SERVICE BULLETIN  
REVISION TRANSMITTAL SHEET

TITLE : AIR CONDITIONING ELECTRICAL INSTALLATION - PROVIDE PROTECTIONS  
AGAINST WATER CONTAMINATION OF ELECTRICAL HARNESS.

This page transmits Revision No. 1 of Service Bulletin No. A320-21-1097.  
No more work is necessary to do this Revision.

SERVICE BULLETIN No. : A320-21-1097

Modification of the Routing of the Vacuum Cleaner  
Figure 1

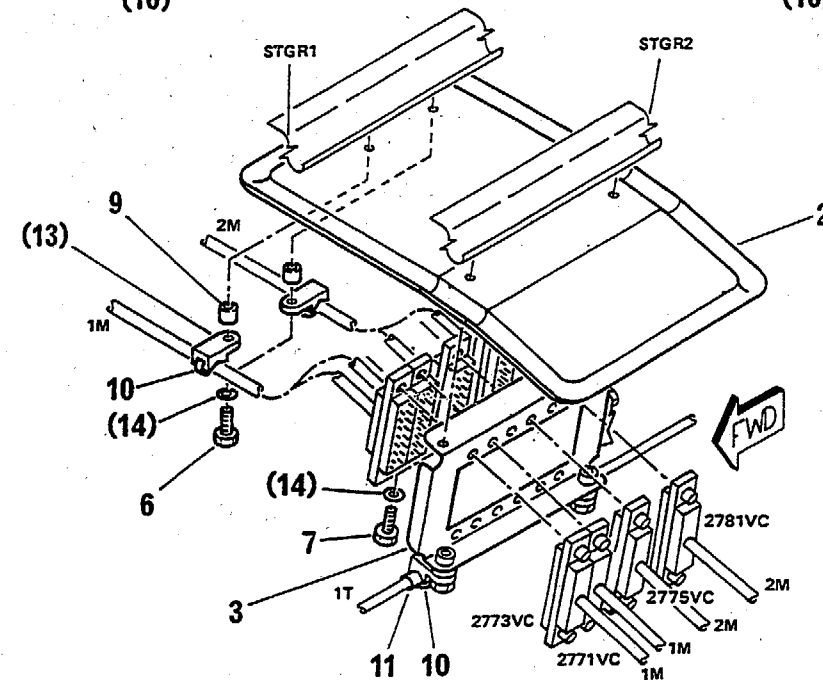
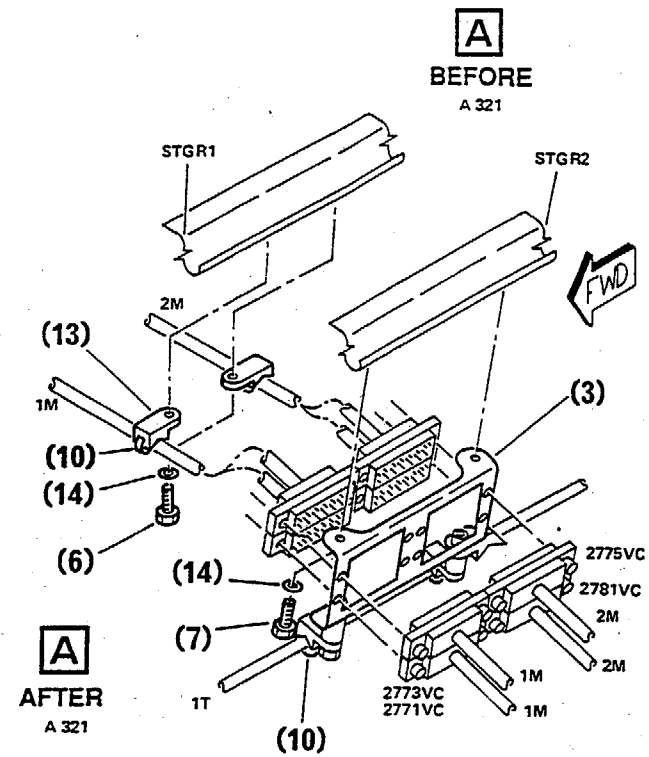
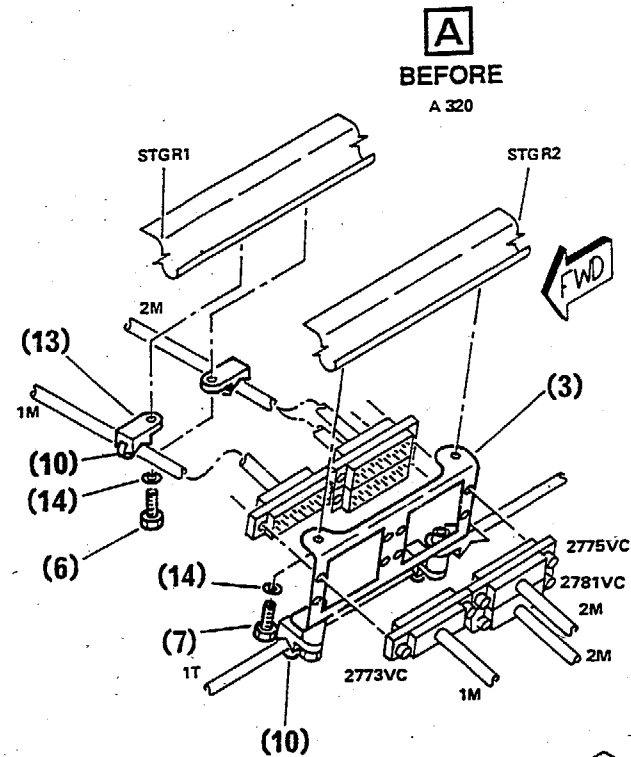
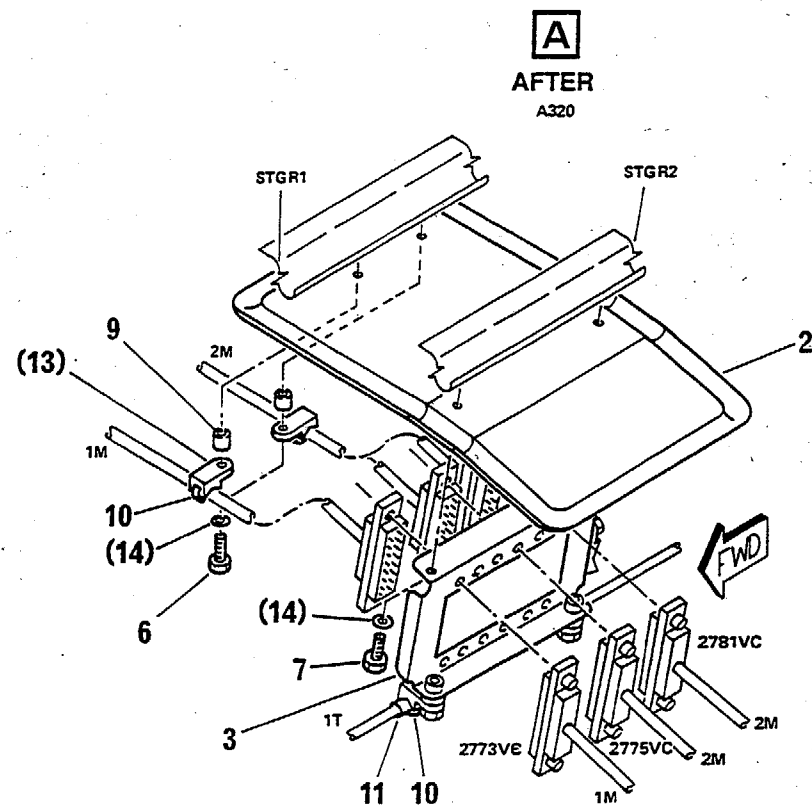
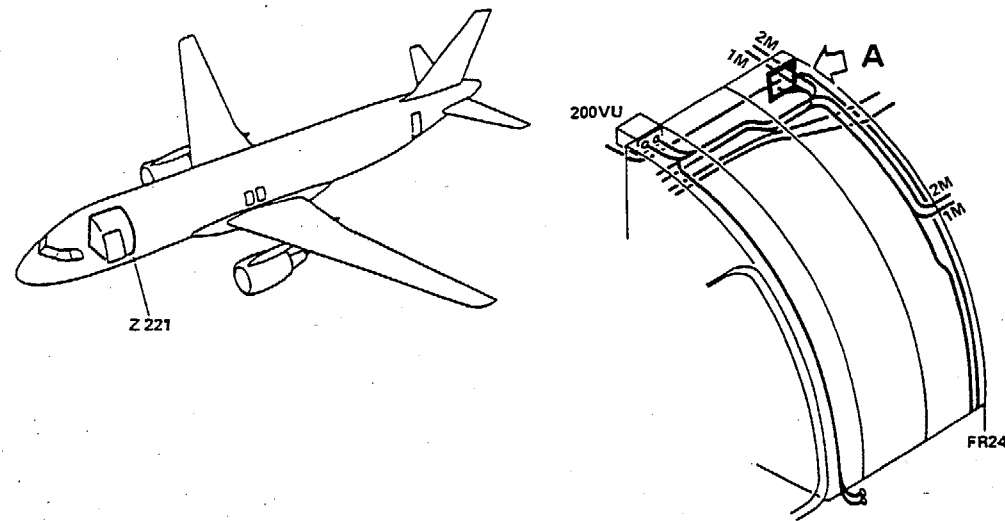
- (1) Modify the routing of the vacuum cleaner between FR20 and FR21.

Refer to Figure 1

- (a) Remove the components which prevent the removal of the  
insulation blanket.
- (b) Remove the insulation blanket between FR20 and FR21  
(Refer to AMM 25-80-00, P. Block 201).
- (c) Installation of the new bracket :
  - 1 Apply sealant Mat. No. 09-018 between the brackets Item 1  
and the stop 1.
  - 2 Put in position :  
1 bracket D5391375200000 Item 1
  - 3 Drill to a dia. of 3.2 mm (0.126 in.)

### 4 Attach with :

2 rivets      ASNA2050DCJ03215      Item 4

### (d) Installation of the routing :

#### 1 Put in position the routing and the two electrical bondings and attach with :

1 clamp	NSA5516-14NV	Item 12
1 washer	ASNA2397-10L	Item 5
1 screw	NAS1096-3-7	Item 8

(e) Cut out the insulation blanket for the passage of the new bracket and apply the adhesive material KB6 on the cut section.

(h) Cut the cable tie Item (10).

(i) Put in position the routing and the two electrical bondings and attach with :

1 cable tie      NSA935401-04      Item 10

Installation of a Drip Pan between FR23 and FR24  
Figure 2

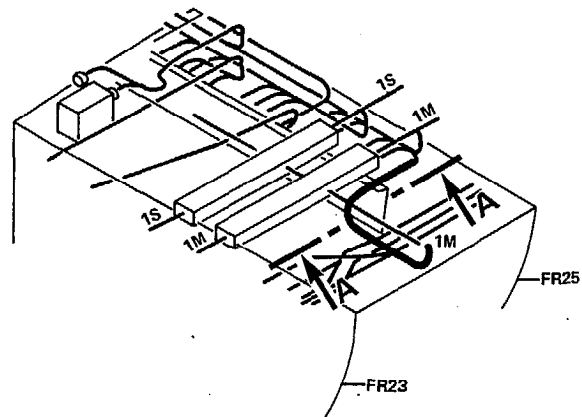
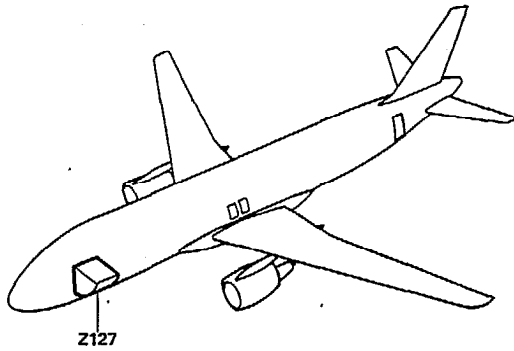
Page 17-18 - Figure 2 modified.

(2) Install a drip pan between FR23 and FR24 on the cabin ceiling.

Refer to Figure 2

(a) Disconnect and remove from the plate assy Item (3) :

- two connectors 2773VC and 2775VC
- or
- three connectors 2773VC, 2775VC and 2781VC.

(c) Remove :

4 cable ties	Item (10) (discard)
2 screws	Item (6) (discard)
2 screws	Item (7) (discard)
4 washers	Item (14) (retain)
2 supports	Item (13) (retain)
1 plate assy	Item (3) (discard)

(d) Install :

1 plate	D9241239020000	Item 2
1 plate assy	D9241239200000	Item 3
2 spacers	NSA5527-03-06	Item 9
2 supports		Item (13)
4 washers		Item (14)
2 screws	NAS1096-3-16	Item 6
2 screws	NAS1096-3-8	Item 7
2 bobbins	NSA935510-02	Item 11
4 cable ties	NSA935401-04	Item 10

(e) Install and connect on the new plate assy Item 3 :

- two connectors 2773VC and 2775VC  
or
- three connectors 2773VC, 2775VC and 2781VC.
